Title - Sujet Building Modernization - Phase 2	
Solicitation No. - N° de l'invitation EC015-140977/A	Amendment No. - N° modif. 006
Client Reference No. - N° de référence du client R.039554.001	Date 2013-09-20
GETS Reference No. - N° de référence de SEAG PW-\$PWB-020-3297	
File No. - N° de dossier PWB-3-36036 (020)	CCC No./N° CCC - FMS No./N° VME
Solicitation Closes - L'invitation prend fin at - à 02:00 PM on - le 2013-09-26	Time Zone Fuseau horaire Atlantic Daylight Saving Time ADT
F.O.B. - F.A.B. Plant-Usine: <input type="checkbox"/> Destination: <input type="checkbox"/> Other-Autre: <input type="checkbox"/>	
Address Enquiries to: - Adresser toutes questions à: Donovan, Janine PWB	Buyer Id - Id de l'acheteur pwb020
Telephone No. - N° de téléphone (506) 636-5347 ()	FAX No. - N° de FAX (506) 636-4376
Destination - of Goods, Services, and Construction: Destination - des biens, services et construction:

This Tender Amendment No. Six (6) is raised to include the following Addendum No. Five (5).

Addendum No. 6.

project **BUILDING MODERNIZATION
PHASE II** project
**10 Weldon Street
Shediac, NB**

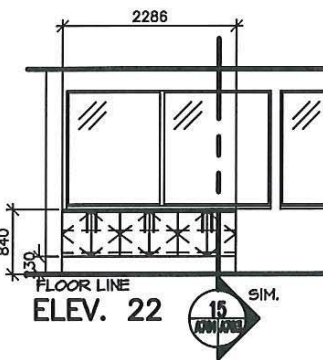
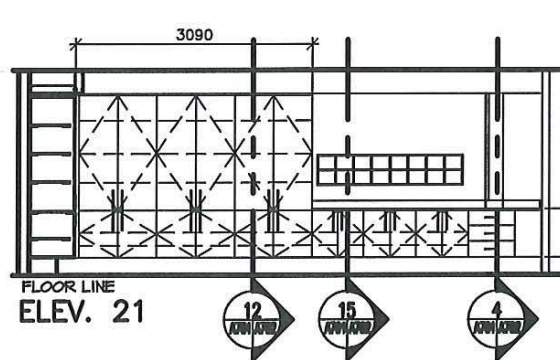
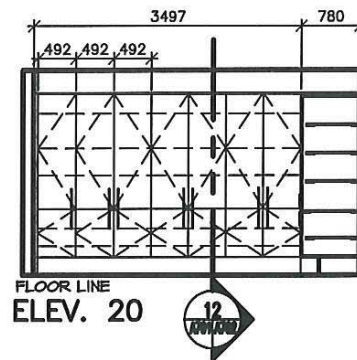
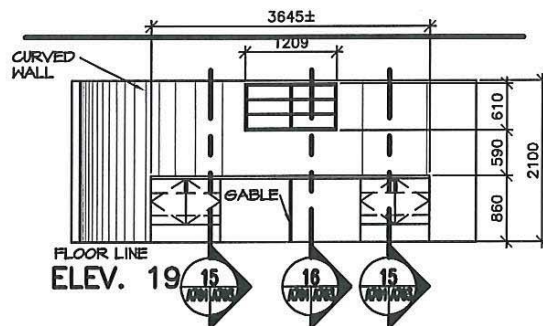
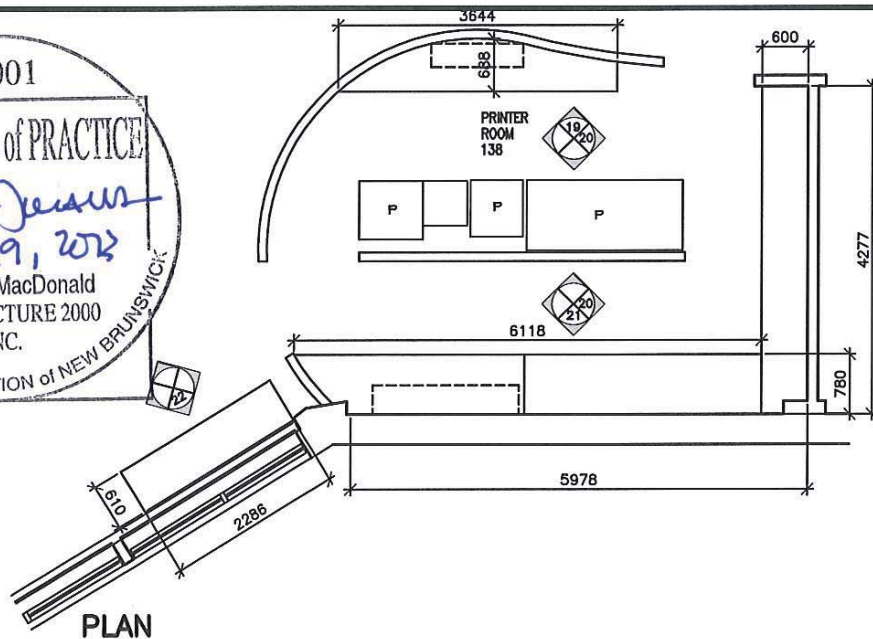
-
- Q6:** In room 138, the large scale floor plan and elevation 21 on detail 5/A-701 do not correspond with each other.
- A6:** Revised: See attached sketch ASK-4.
